Landmarks & Urban
Conservation Commission

Agenda Number: 5
Case No.: 16-LUCC-50013
Project # 1010796
April 13, 2016

Staff Report

The applicant proposes to make changes to the street right-of-way and sidewalks in the Urban Conservation Overlay Zone (UCOZ) in accordance with the planned Albuquerque Rapid Transit (ART) project. This application pertains to one segment of the larger ART project located between John and Locust Streets SE. No additional right-of-way is required to implement the project. Sidewalks are widened in locations where they can be accommodated and narrowed in limited locations. Most existing street trees, including those in the median, will be removed and new trees added where they can be accommodated by the project design. The overall number of street trees in the district will be increased as will on street parking spaces. A bus loading platform would be constructed at Walter Street in between the traffic lanes; the platform does not feature a canopy cover as would be found on the rapid transit line in other areas of the city.

EDO HIGH - I-25

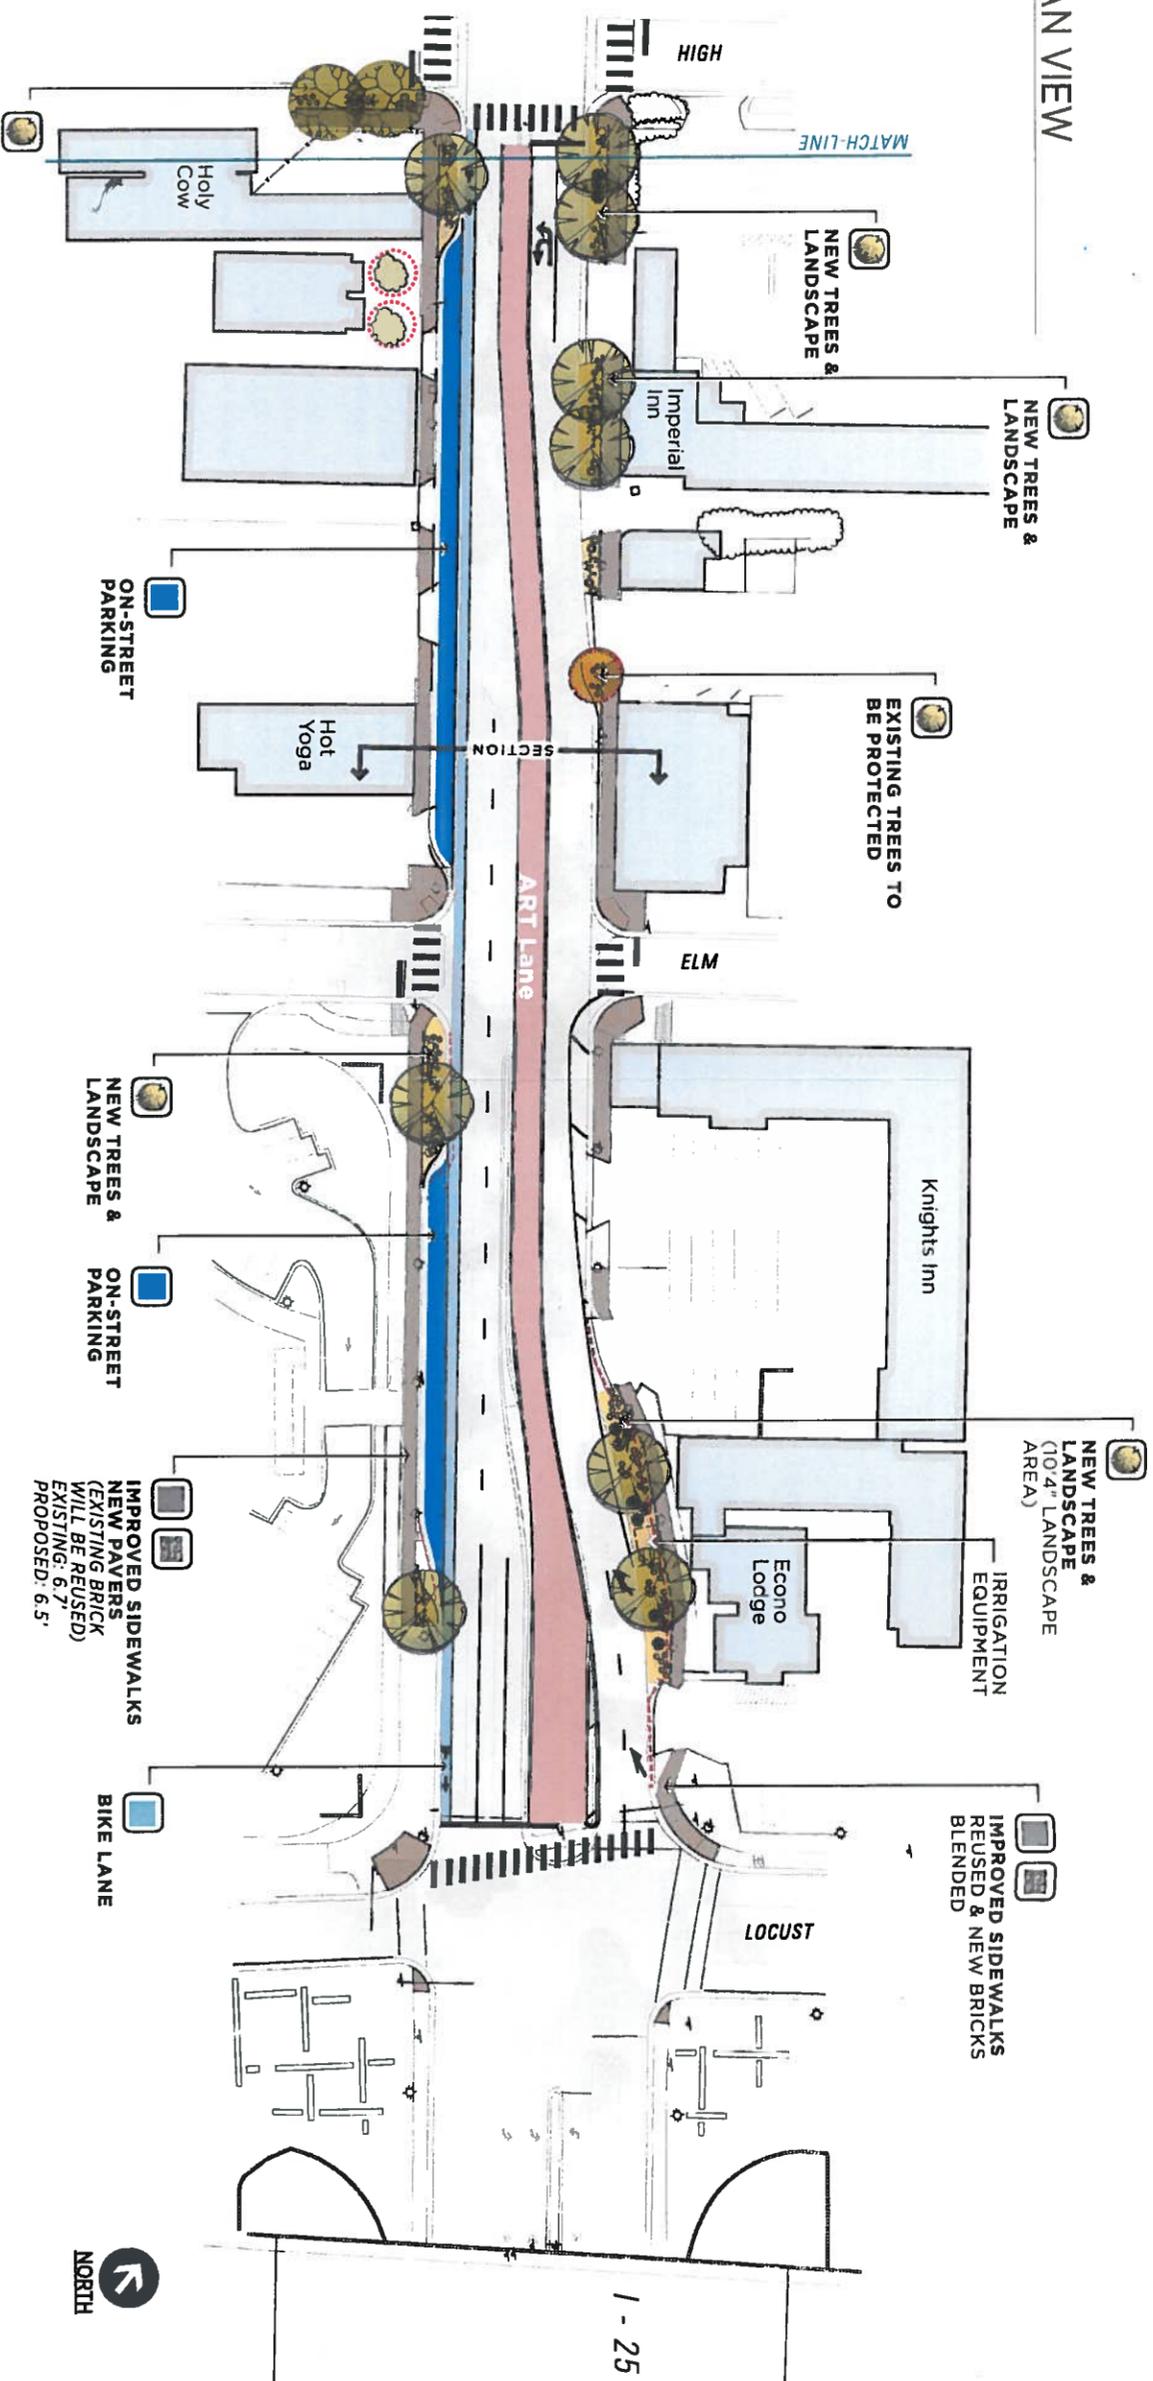
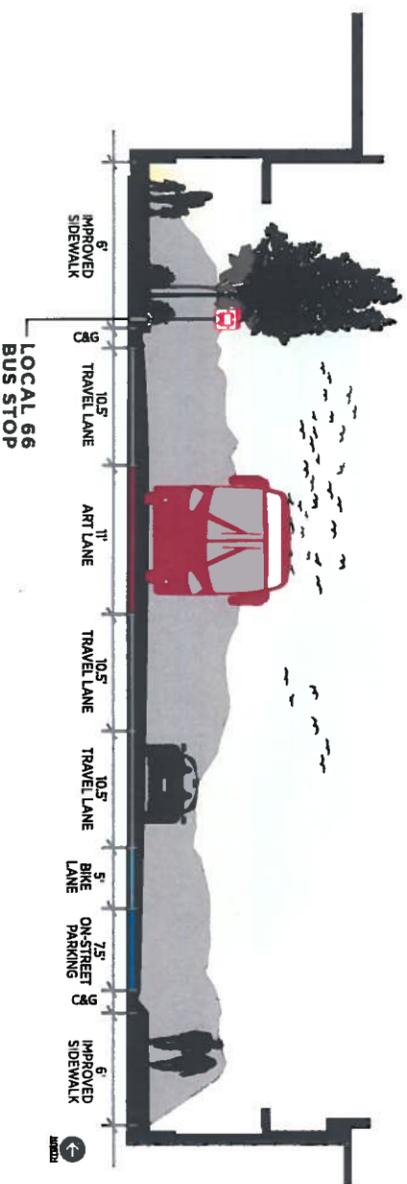
No additional right-of-way is being taken for implementation of the ART project in this district, and as such, the project is subject to unalterable constraints. The proposal does not meet the prescriptive criteria for street trees in the Regulatory Plan. The applicant requests a deviation as allowed by the Plan. The applicant provides information about both the new trees to be added and existing street trees affected by this project. The existing trees in the medians will be removed along with the medians.

The applicant requests a deviation from the street tree standards justified by other adopted policies and consistency with the criteria for approval of a deviation. Staff agrees that the deviation is justified because the project is consistent with the intent of the Plan for the UCOZ. The project seeks to make substantial improvements to transit as well as to the streetscape. The location of street trees should not interfere with the enjoyment of land in the vicinity. The project adds landscape and street trees. It would be an unnecessary hardship to design this significant public investment around the placement of trees. The ability to provide street trees at exactly every 28 feet is dictated by the site constraints, not financial considerations.

the proposed streetscape. Central Ave. is designated as a major transit corridor in the Albuquerque Bernalillo County Comprehensive Plan. The identified modal hierarchy dictates that transit should be accommodated. A deviation to this standard is justified because the project is consistent with the intent of the Plan for the UCOZ. The project seeks to make substantial improvements to transit as well as to the streetscape. The location of street trees should not interfere with the enjoyment of land in the vicinity. The project adds landscape and street trees. It would be an unnecessary hardship to design this significant public investment around the placement of trees. The ability to provide street trees at exactly every 28 feet is dictated by the site constraints, not financial considerations.

EXHIBIT "B": Street Furniture at the Walter Street Platform

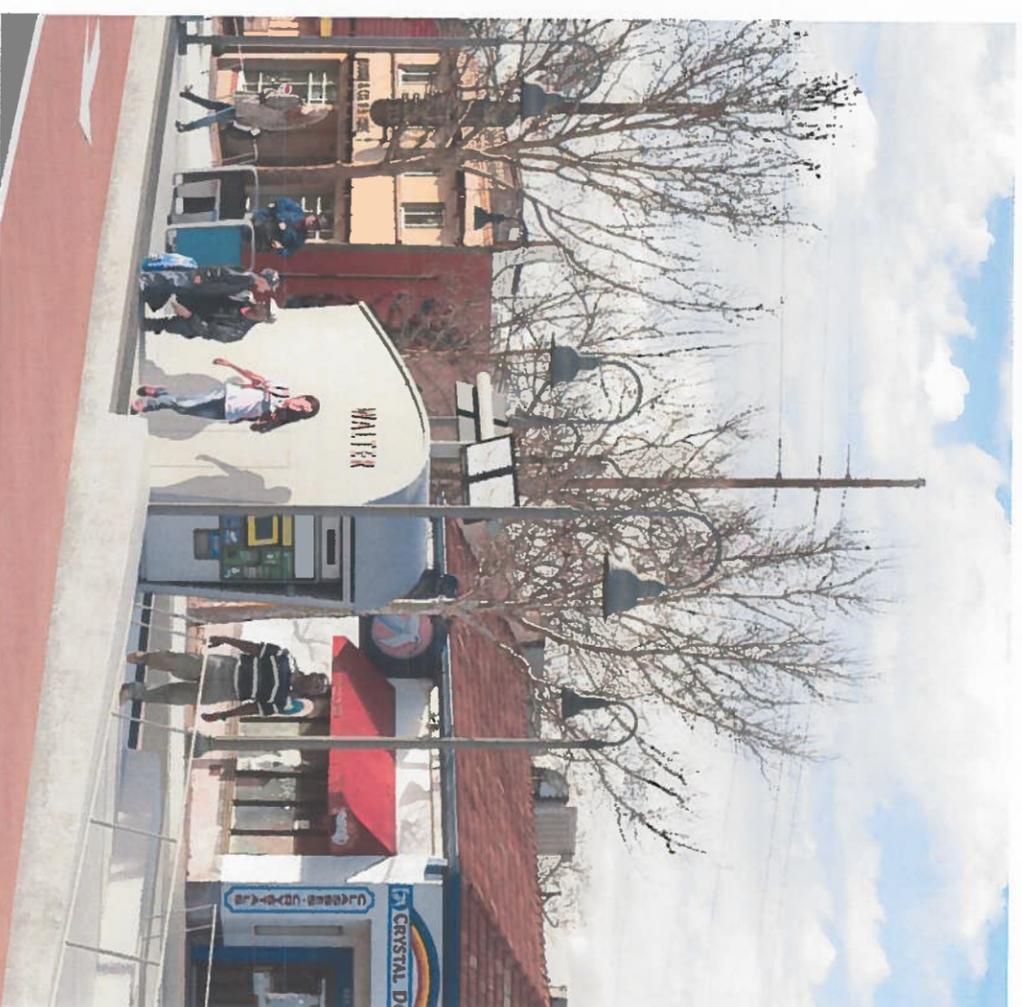
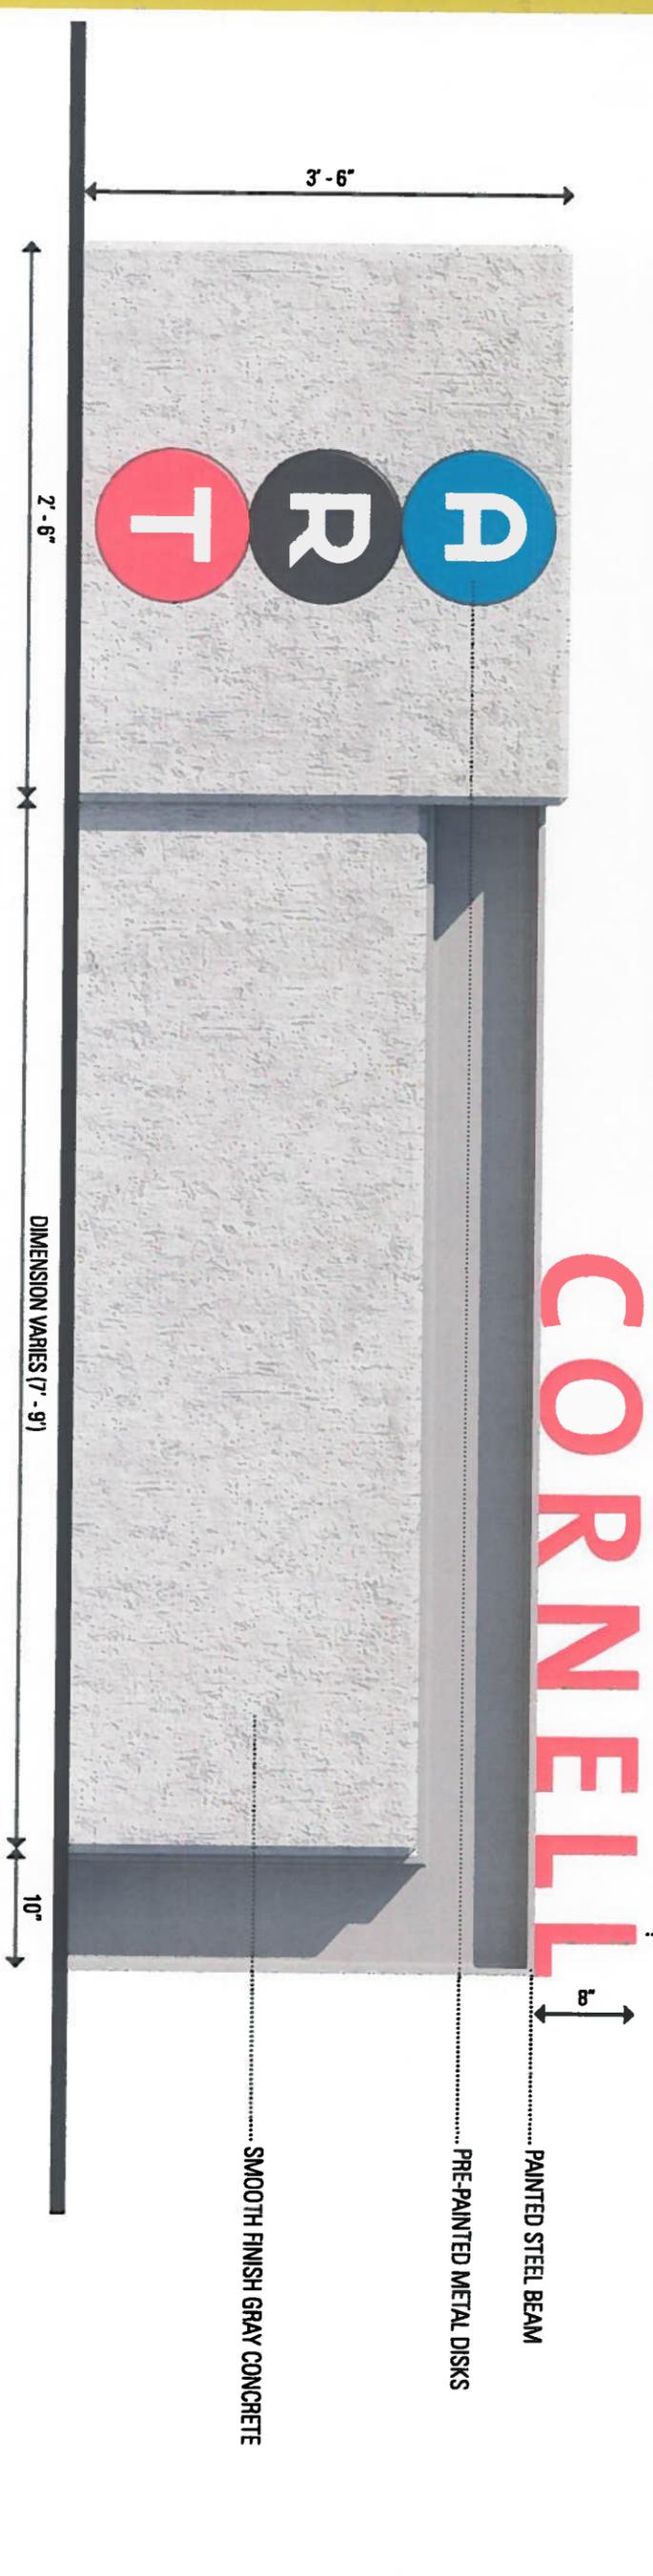
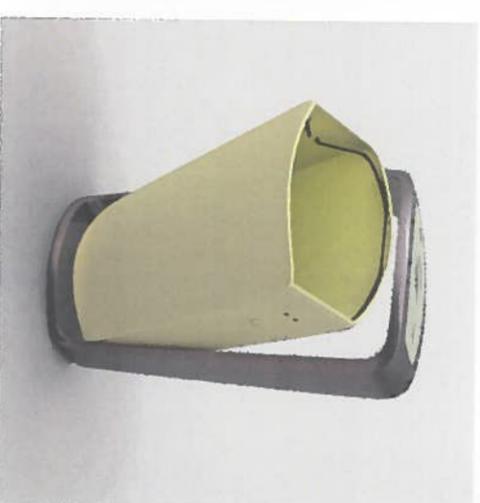
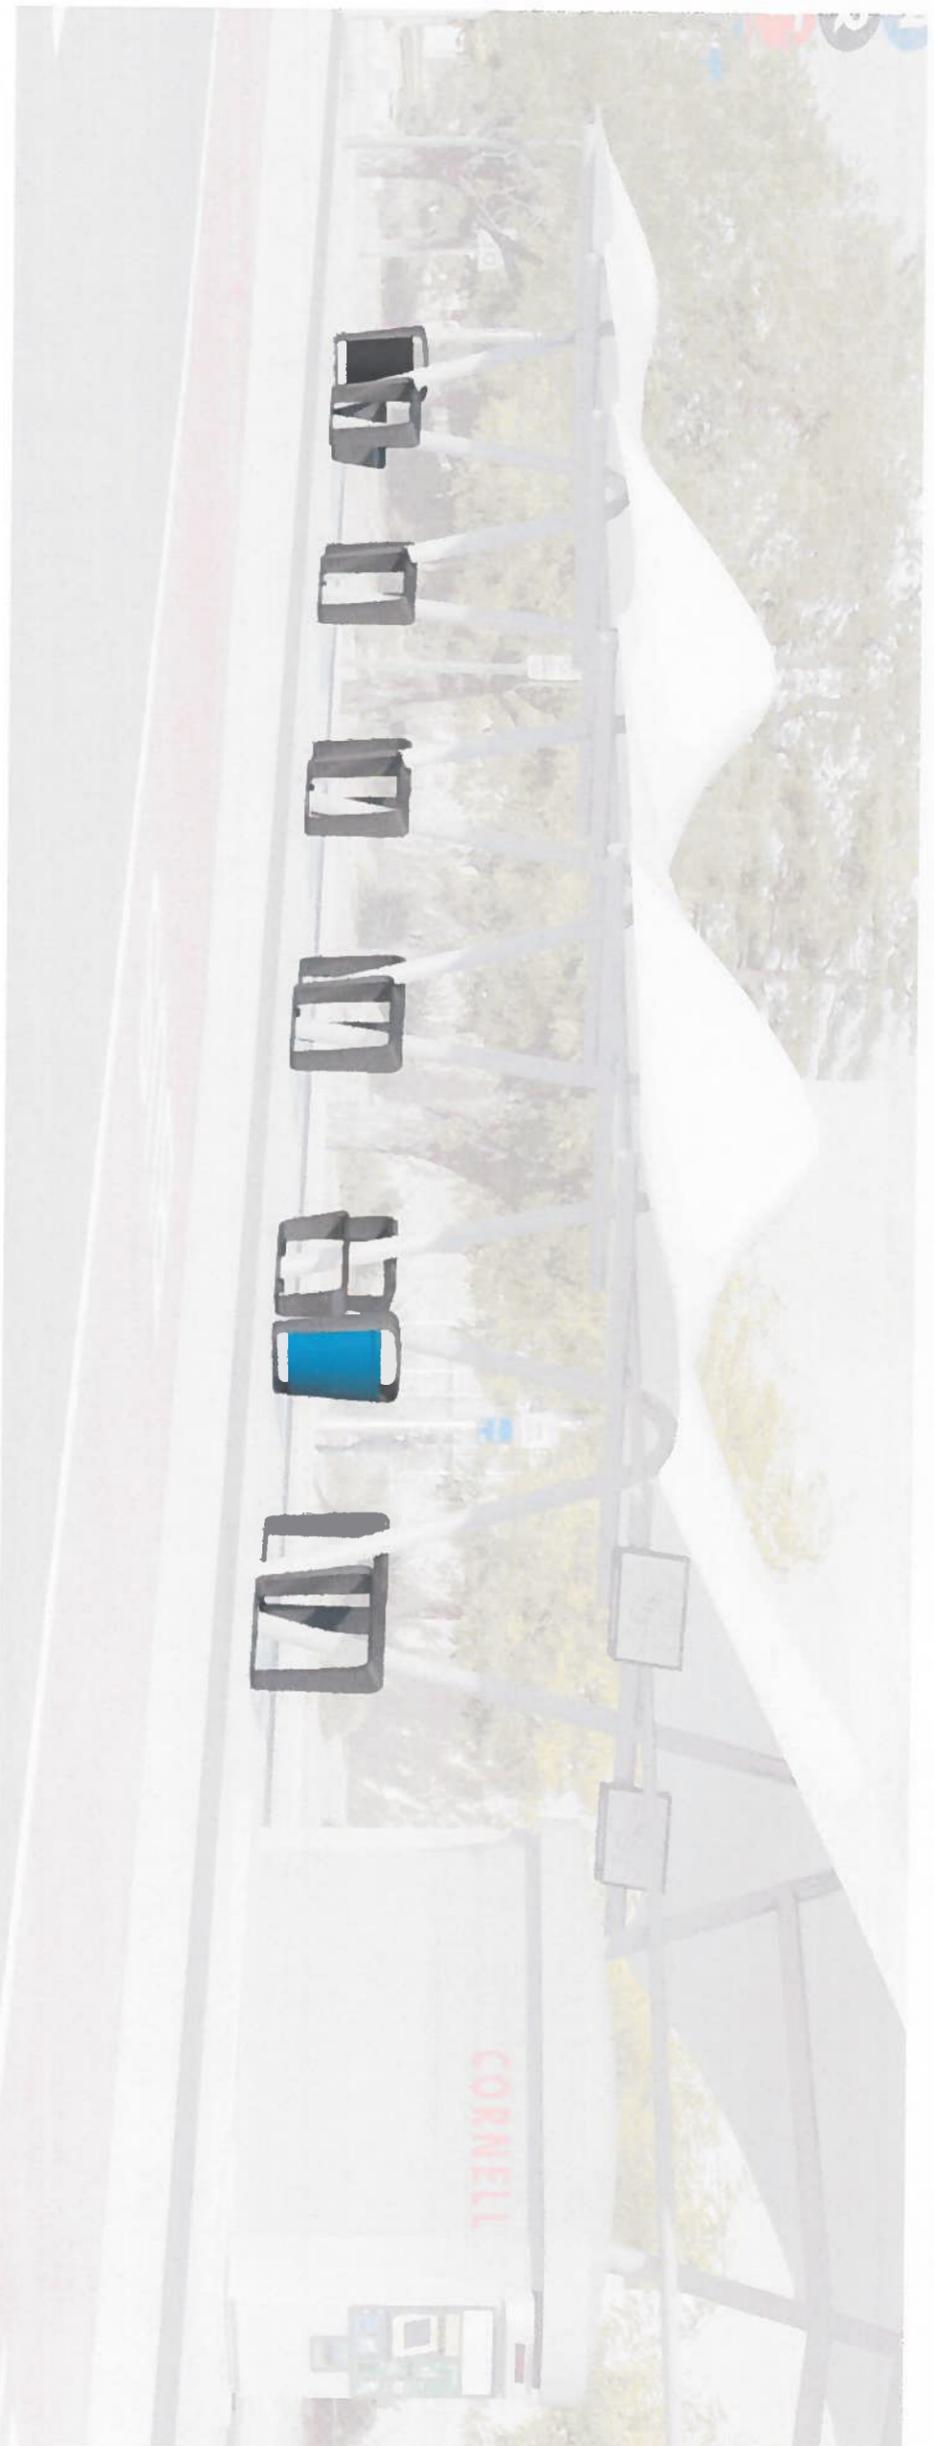
6. The proposal is consistent with Regulatory Plan (guidelines) in that the site furnishings as portrayed in the applicant's Exhibit "B" are simple and streamlined and they do not conflict with the "historic character" of the UCOZ. The architectural character of the UCOZ is not consistent. The HH-Edo UCOZ features a variety of commercial and institutional buildings reflecting the continuum of time periods in Albuquerque's history and a very diverse mix of architectural styles. The UCOZ also contains contemporary live/work mixed use buildings.
